I have reviewed your proposal for Phase I evaluations concerning the interim remedial action for the on-site landfill at the Randall-Textron location in Grenada, MS. Your proposal is generally acceptable, but the following questions and concerns need to be addressed:

Re: Modification of  
Equalization Lagoon  
Closure Plan, Randall  
Textron - Grenada, MS

Subject: Request for Modification  
Equalization Lagoon Closure Plan  
Randall Textron  
Grenada, Mississippi

Re: June 9, 1993 - Request for Modification  
Equalization Lagoon Closure Plan  
Randall-Textron - Grenada, MS

FIGURE 1  
RANDALL TEXTRON  
GRENNADA, MISSISSIPPI

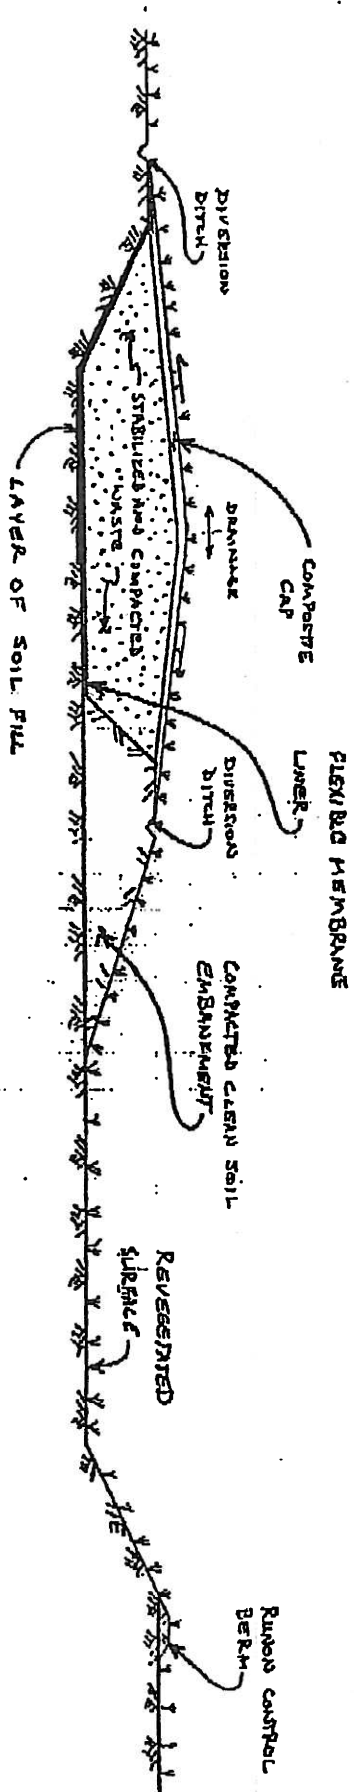
**Lagoon Bottom Modification** - The depth of the lagoon within the northwest end may exceed the depth to groundwater as noted previously. Therefore, a protective layer of soils would be installed over the base of the lagoon as necessary to eliminate potential contact between groundwater and the stabilized waste, as shown schematically on Figure 1.

**Cell Construction** - Once the pond bottom soils have been placed and compacted, a retention berm would be constructed as shown on Figures 1 and 2. Following construction of the berm, the resulting cell would be lined with a flexible polyethylene membrane. This membrane would be anchored around the perimeter of the cell to provide permanent containment. The lining material would be placed, seamed, and inspected using a defined QA/QC protocol.

FIGURE 2  
RANDALL TEXTRON  
GREENADA, MISSISSIPPI

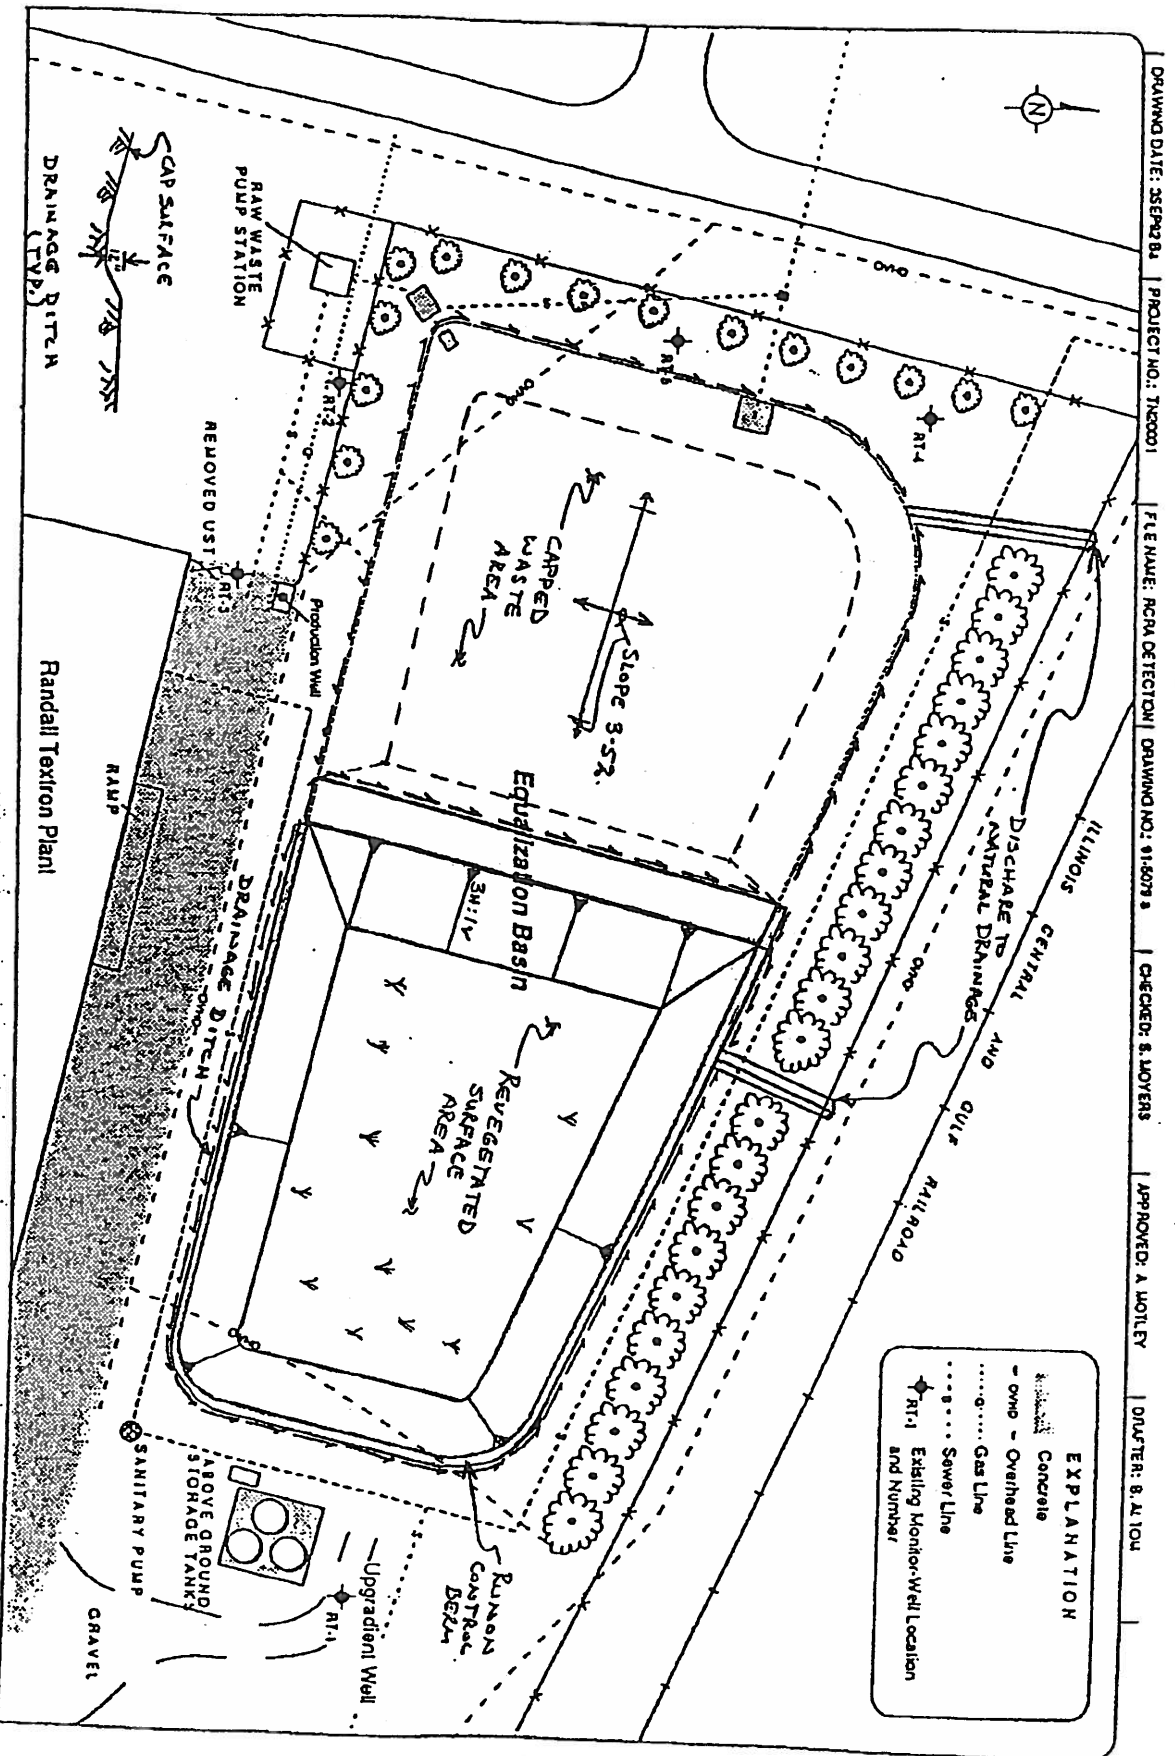
Final grading of the cap would provide for positive drainage to the perimeter drainage ditches shown on Figure 2. The final surface would have slopes of at least 3 percent, but no more than 5 percent, as shown in Figure 3.

**Drainage System** - An integral part of the final cap would be development of a defined surface water drainage network. This network would be comprised of drainage ditches and run-on control berms as shown on Figure 2. In general, the surface water collected, would be discharged to natural drainage in the ditch which runs between the lagoon and the railroad tracks. The configuration of the ditches would be developed based upon final elevations of the cap and the existing ditch profile.
